REVIEW OF WATER DEMAND AND UTILIZATION
STUDIES FOR THE PROVO RIVER DRAINAGE BASIN,
AND REVIEW OF A STUDY OF THE EFFECTS OF THE
PROPOSED JORDANELLE RESERVOIR ON SEEPAGE TO
UNDERGROUND MINES, BONNEVILLE UNIT OF THE
CENTRAL UTAH PROJECT

By K.M. Waddell, G.W. Freethey, D.D. Susong, and G.E. Pyper

U.S. GEOLOGICAL SURVEY
Open-File Report 91-514

Figure 2.3.3-4--Effects of reducing or increasing surplus flow of Provo River at Deer Creek Dam on end-of-year contents in proposed Jordanelle Reservoir.

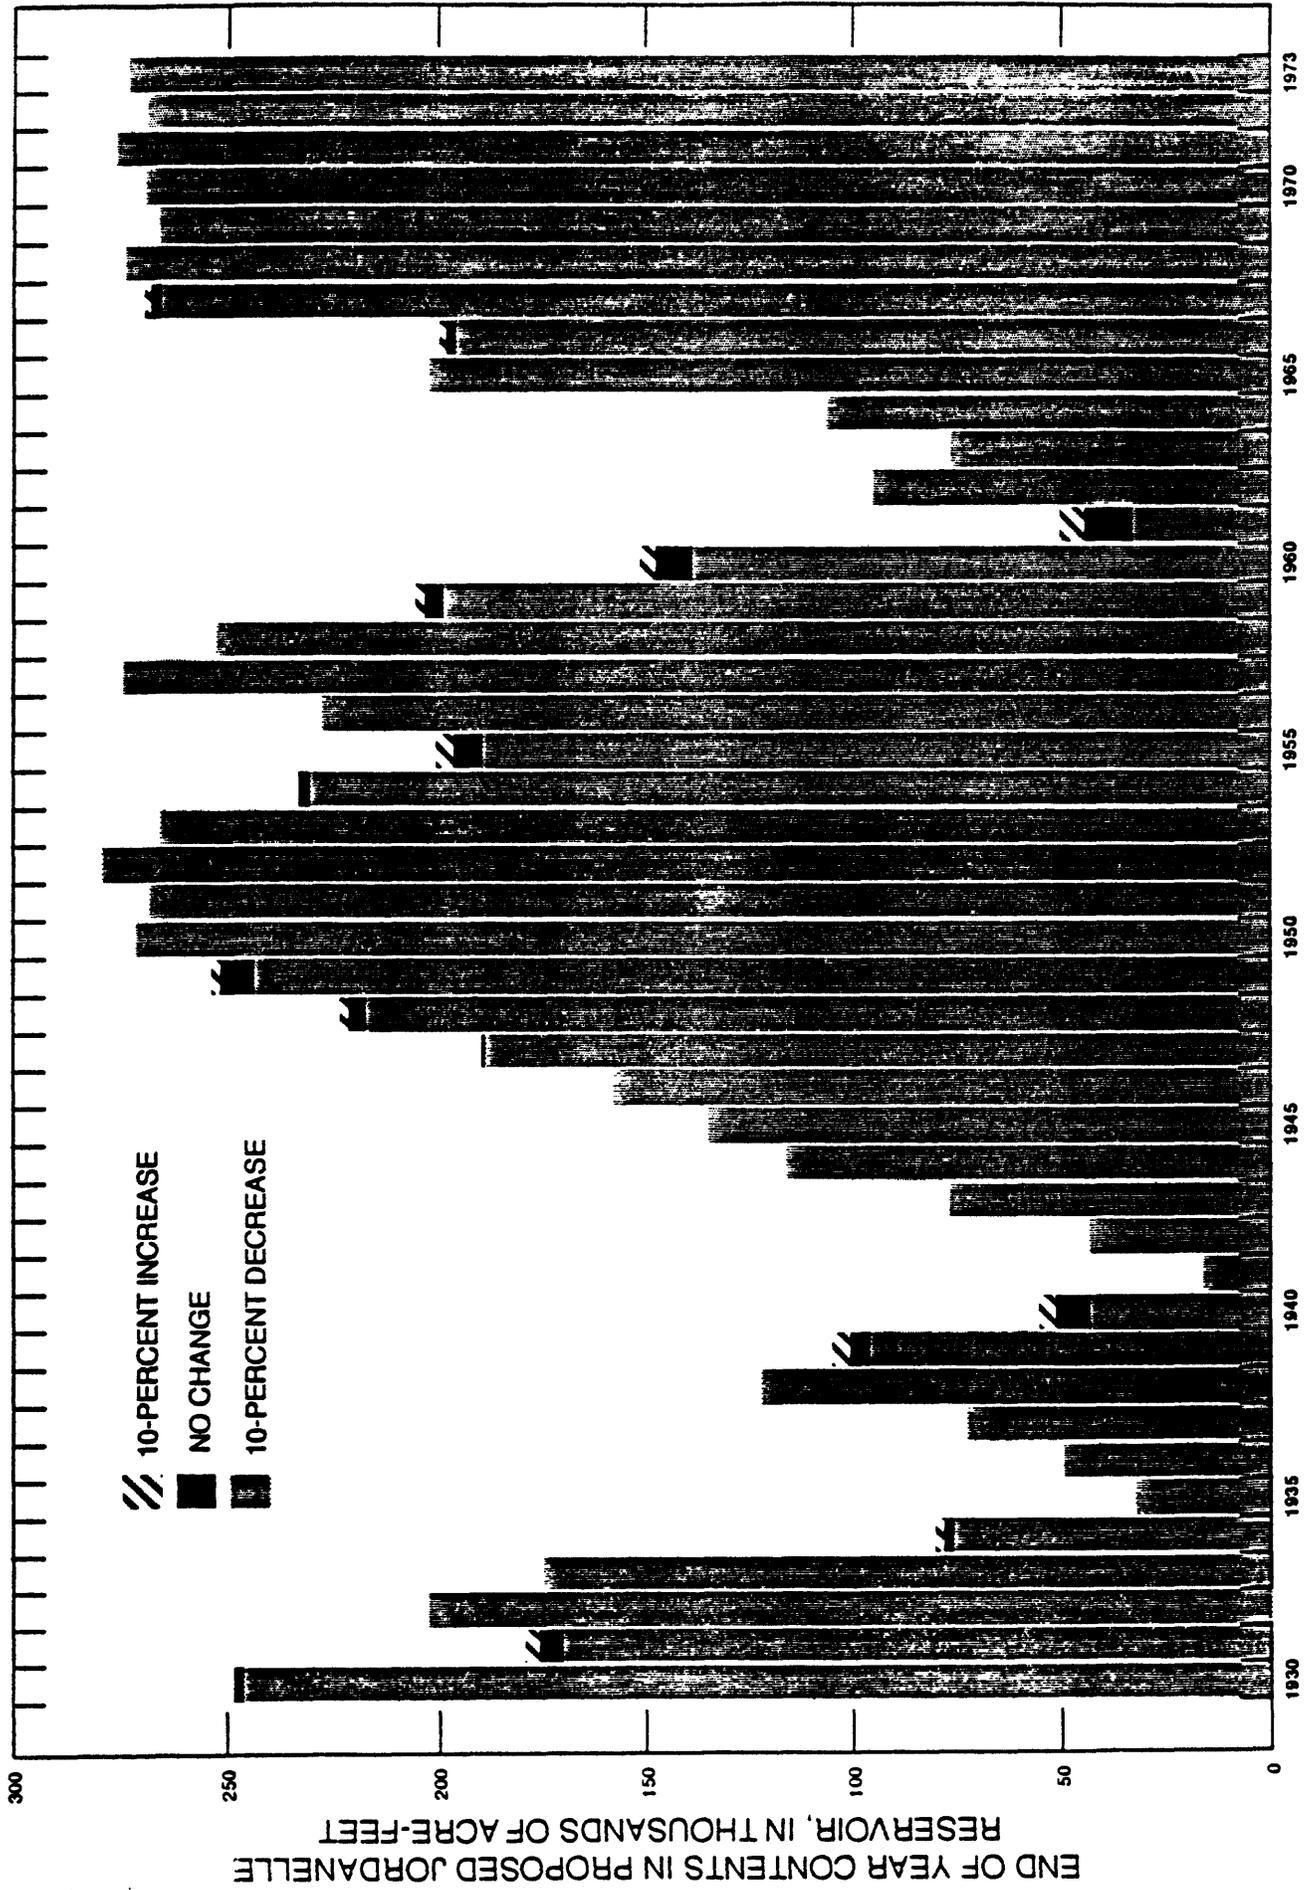
The response of the model to changes in surplus flow at Deer Creek Dam was evaluated (plus or minus 10 percent) (column 19, fig 6.0-4). The response function for the change in surplus flow was the end-of-year contents in Jordanelle Reservoir (column 78, fig. 6.0-4). The contents of Jordanelle Reservoir should respond to changes in the surplus flow even though Deer Creek Reservoir is downstream from Jordanelle Reservoir. As can be seen in figure 2.3.3-4, the end-of-year contents of Jordanelle Reservoir did respond and increased by a maximum of about 15,000 acre-feet when the surplus flow at Deer Creek Dam was increased by 10 percent.

Some values are fixed or constant in the model, and the model does not respond dynamically to some changes of input values. Because many of the values were fixed as constants in the model, only a partial sensitivity analysis could be conducted as part of this review. Also, the combined effects of the small errors or inconsistencies pointed out in this review could not be quantitatively evaluated because the model does not react dynamically.

Figure 2.3.3-5--Summary of annual water supply, water use, and depletion in Utah Lake.

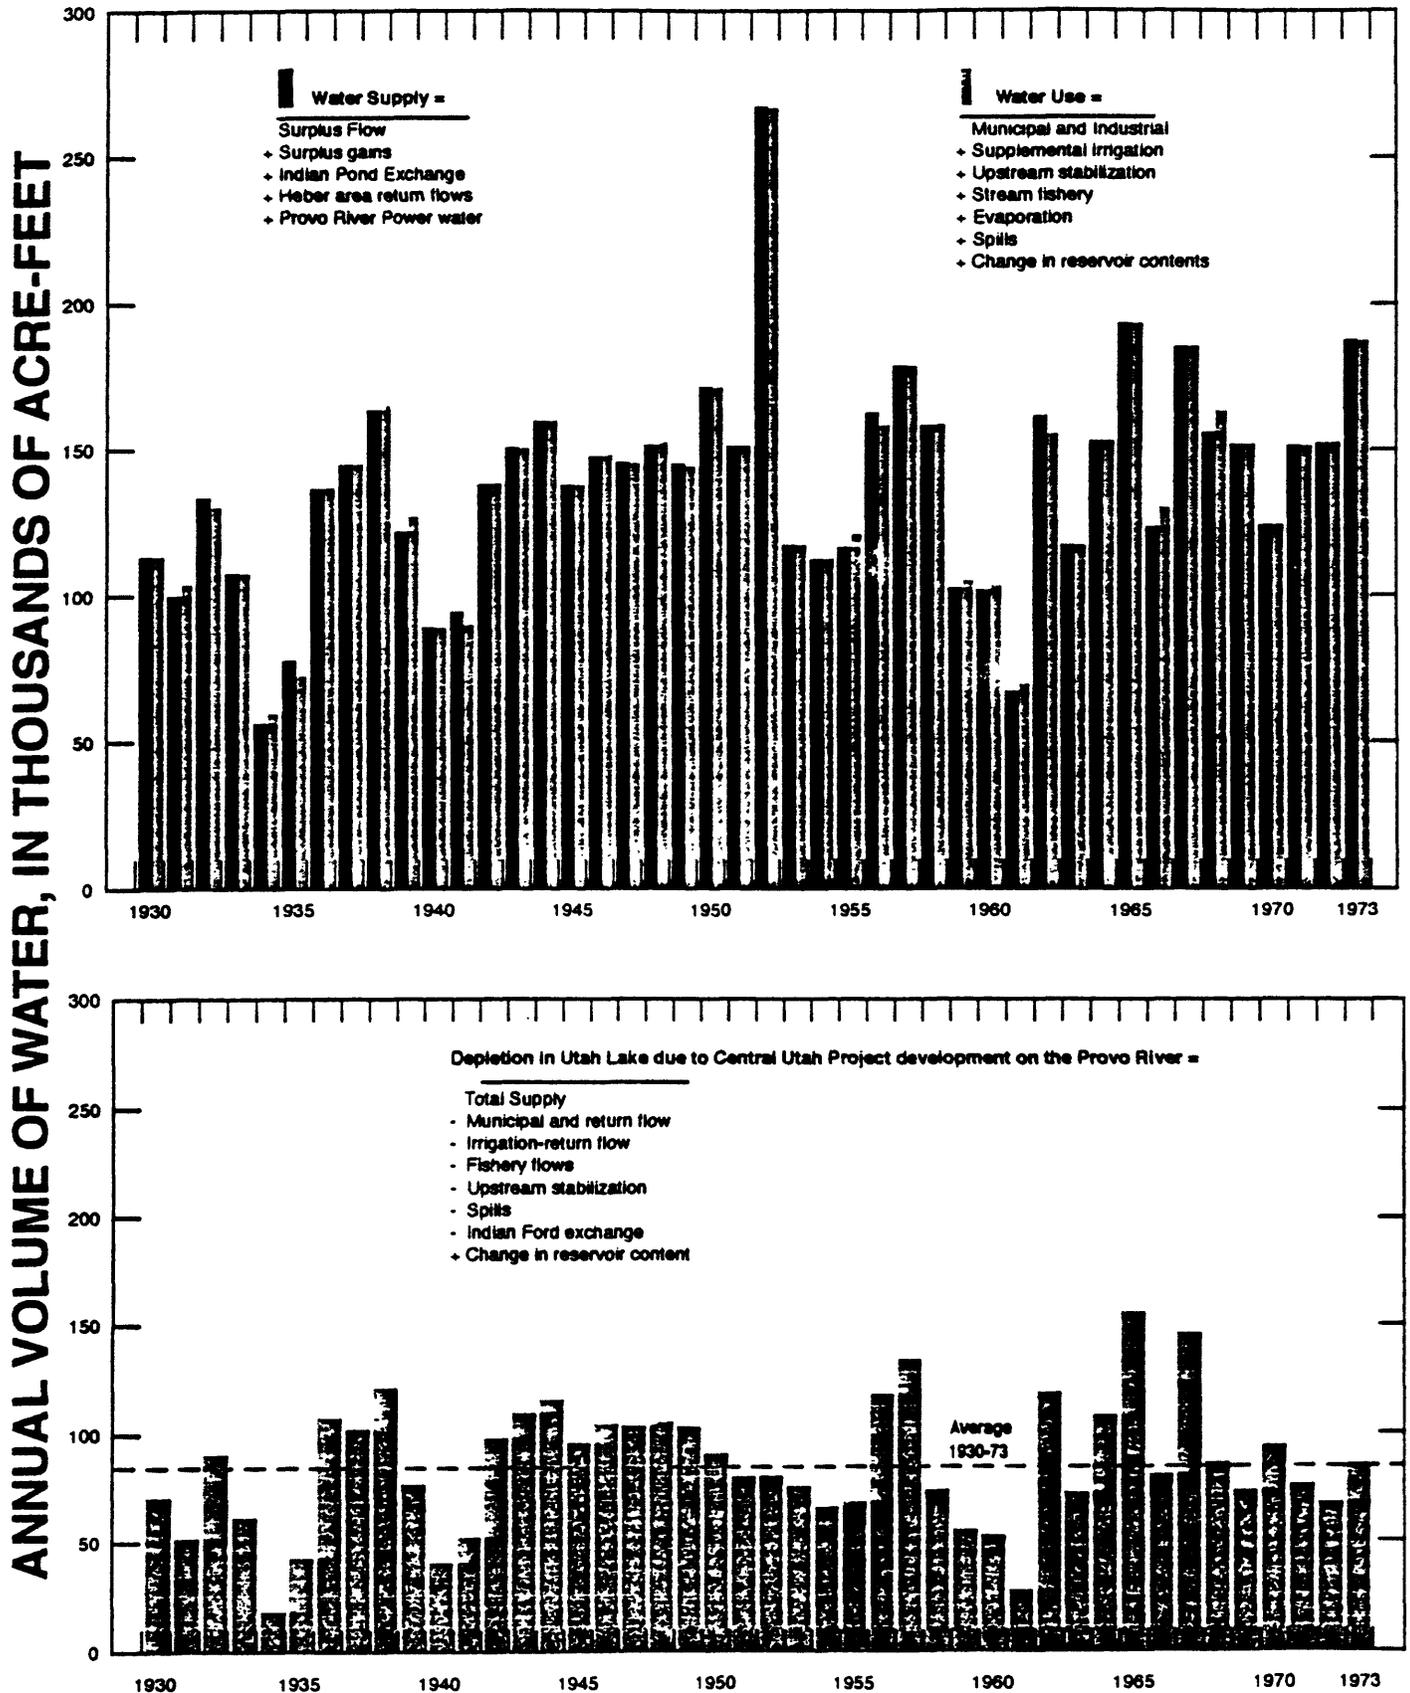
The water supply, water use, and Utah Lake depletion were also computed on an annual basis to check the annual balance between water supply and use and to determine the annual average variation of the depletion of Utah Lake. Comparison of water supply and use in figure 2.3.3-5 shows that the annual average water supply does not balance every year. The year-to-year discrepancies are minor and may reflect computational inaccuracies of the model that are probably larger for year-to-year accounting than for the 1930-73 average. The USGS reviewers did not determine the causes of these differences.

The annual average depletion to Utah Lake ranged from 17,800 acre-feet to 156,200 acre-feet and averaged 85,600 acre-feet for the simulation for 1930-73 using the updated model code. The years when depletions were larger than average (85,600 acre-feet per year) are important for consideration because of the year-to-year variability required for importation of water from Strawberry Reservoir. Figure 2.3.3-5 shows that in 15 of the 44 years, the depletion will be 100,000 acre-feet per year or larger and deliveries from Strawberry Reservoir would have to meet the variable depletions to prevent project shortages.

The model for the Jordanelle Reservoir Operation Study is not a dynamic model that can be used to simulate operation of Jordanelle Reservoir on a real-time basis. A number of data columns are read into the model and fixed for the 1930-73 period. The model was designed to distribute water in the Provo River drainage basin under set project conditions that are valid only for the 1930-73 base period. For any other base period, these constants would have to be revised manually. For example, if the streamflow in the Provo River at Hailstone were changed, the downstream reservoirs and gaging stations would not reflect the change of flow at Hailstone.

Figure 3.2.4-1--Boundary of the ground-water-flow model used to determine seepage to mines.

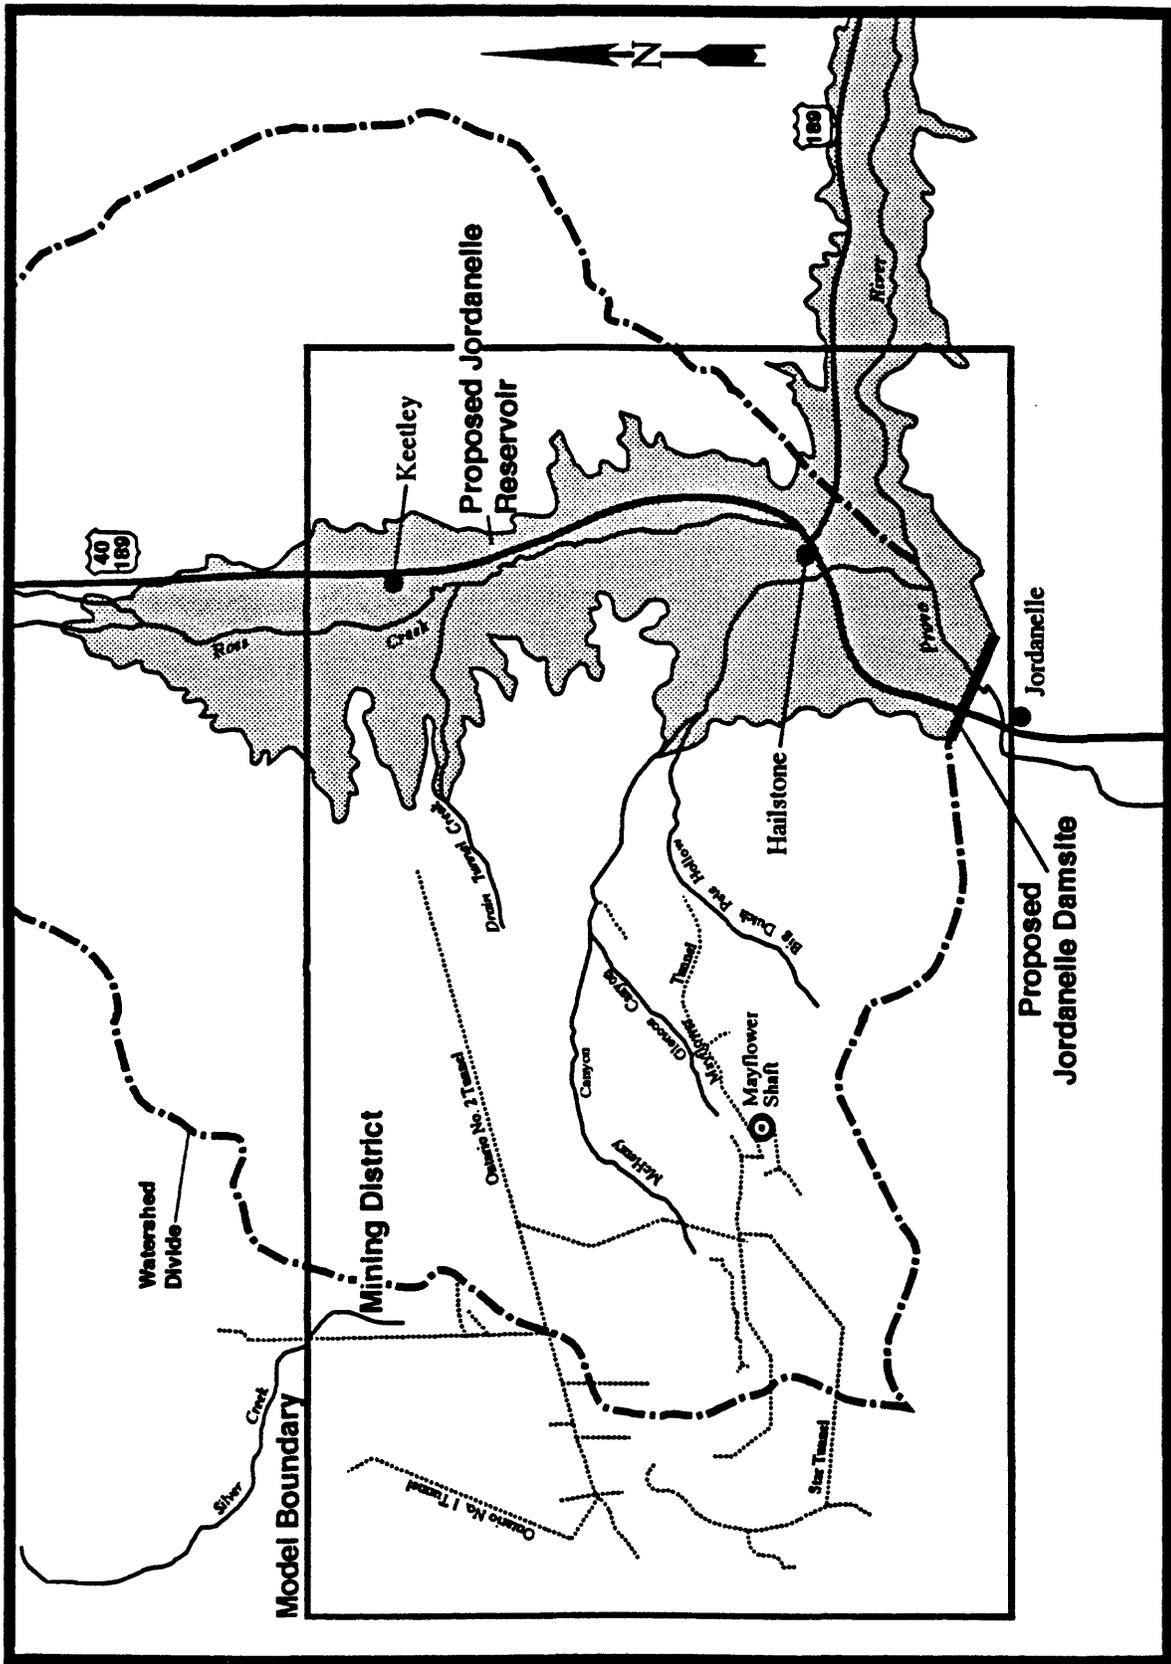
The model was run only in steady-state mode; thus, transient response and storage effects were not considered. The model was “calibrated” by adjusting hydraulic-conductivity values until a model node representing the Mayflower Shaft at a constant head of 4,400 feet allowed discharge approximately equal to the average pumping rate that had been required to dewater the shaft to a level of 4,400 feet during mining operations. The model was run first using hydraulic-conductivity values derived from field tests and best estimates; second using hydraulic-conductivity values one order of magnitude smaller than field tests and best estimates; and third using a uniform value of 0.15 feet per day for hydraulic conductivity.

The constant-head boundaries prevent heads from responding appropriately to stresses. Mine dewatering could cause actual heads to fluctuate significantly in the areas where constant heads are specified. Likewise, the filling of the reservoir would likely change heads in regions that are modeled as constant heads. The use of constant-head nodes to simulate the Ontario Drain Tunnel No. 2 is a major concern because of its proximity to the Mayflower Mine. The dewatering at the mine causes a very steep head gradient between the drain and the mine in the model. Because of the constant head, the cone of depression cannot extend beyond the drain.

The constant-head boundary at the model perimeter is substituting for areal recharge, which is the natural source for most of the water flowing through the system. Instead of simulating the recharge that infiltrates in upland areas and alluvial material, the constant-head boundaries are supplying the water that flows through the modeled system. Recharge depends primarily on the quantity of precipitation whereas flow from constant-head nodes depends on hydraulic conductivity and head gradient; therefore, it is impossible for the constant-head boundaries to supply the correct quantity of recharge under all the conditions being simulated.

Further, even under natural conditions, the model was not calibrated on the basis of total flow through the system. Calibration was based entirely on seepage to the mines, which is a small fraction of total flow through the modeled region. It is possible, especially considering the large number of constant-head nodes, to have a model that produces correct heads without having the correct flows. If flows as a whole are incorrect, then hydraulic-conductivity values are also incorrect. As a result, any predictions based on the model would be meaningless.

The one-layer model does not consider vertical flow. Because the consolidated rocks are highly fractured, because water-level hydrographs show different response times to areal recharge, and because the formations vary with depth, especially under the reservoir area, an understanding of vertical flow in this hydrologic system is critical to determining the quantity of seepage into existing and hypothetical new mines. A model simulating only one layer cannot adequately represent this complex system.
